**AGENDA**  
**Historic Yorktown Design Committee**

York Hall  
East Room  
301 Main Street, Yorktown  
February 21, 2024  
7:00 PM

## MEMORANDUM

**SUBJECT:** Application No. HYDC-247-24; York County Board of Supervisors, 425 Water Street

South Elevation

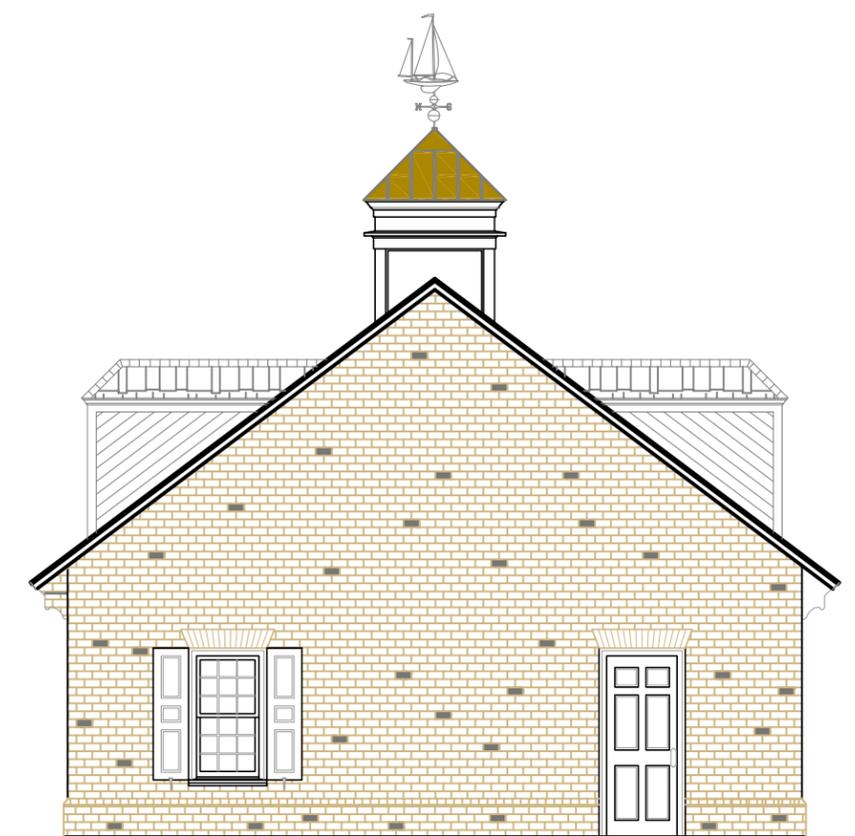
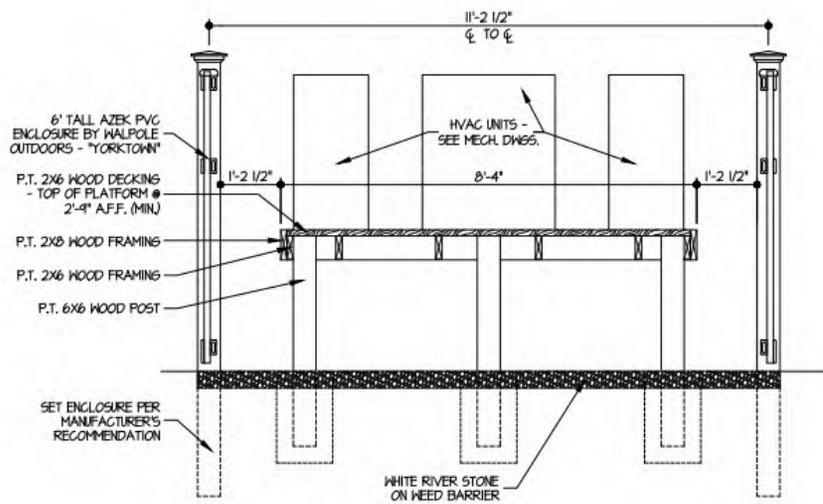
<p>The overall height of new construction should relate to that of adjacent structures and to the objective of maintaining desirable views to and from the Waterfront and the adjacent bluffs and other significant vantage points.</p> <p>d. Roof Shapes</p> <p>(1) Roof shapes should be a traditional gabled style with a slope consistent with those found on <i>pivotal</i> and <i>contributing</i> buildings throughout the village. Roof shapes and orientation should be designed with consideration given to maintaining views and visibility from the bluffs and other significant vantage points.</p> <p>(2) Flat roofs, although they may optimize views from the bluffs and other significant vantage points, should be avoided since they will not produce the quality and character appropriate for the Waterfront.</p> <p>e. Design</p> <p>(1) Overall building design should be consistent with the character of Yorktown and particularly the style, shape and massing of the buildings on Main Street.</p> <p>(2) Standard, corporate designs for national franchise businesses should be avoided unless these designs are compatible with the character of the Yorktown Waterfront.</p> <p>f. Sense of Entry/Orientation</p> <p>All primary buildings should have an orientation and entrance to Water Street. Buildings on parcels located between Water Street and the York River should also have a façade developed to orient to the river. Entries should be articulated with covered porches, porticos or other pronounced architectural forms.</p> <p>2. Architectural Elements</p> <p>a. Walls</p> <p>(1) Wall materials should be compatible with those of existing construction in type, color, texture, size, spacing, and general appearance. Weathered, stained or painted wood, and brick are the preferred materials in the Waterfront area. Composite or synthetic wood or wood substitutes may be approved by the HYDC on a case-by case basis.</p> <p>(2) Wood siding should be horizontal clapboard (beaded edge or beveled) with approximately 6 inches exposure. Trim should be made of trim-</p>	<p>The height of the main massing is 30 feet and three inches with the cupola and 23 feet 10 inches without the cupola. The closest structure is the three-story Yorktown Beach Hotel which sits at a higher elevation.</p> <p>The roof shape is a traditional gable with a lower slope to keep the building height low.</p> <p>No flat roof is proposed.</p> <p>The use of brick, gable roof, and dormers, all contribute to consistency of character with other structures in Yorktown.</p> <p>None are proposed.</p> <p>The building has entrances that serve both the beach side and Water Street side. Entry ways are articulated by jack arch lintels of brick.</p> <p>Brick will be the primary material for walls. The dormers are proposed to have composite wood shiplap siding. A cellular PVC board will be used for the cupola.</p> <p>The siding is proposed to be horizontal six-inch (6”) shiplap siding. Trim meets the size requirements.</p>

7. Fencing around the outside mechanical equipment shall be made from composite wood, painted white, and screened with evergreen landscaping.
8. The sign brackets shall be black or some other matching color.
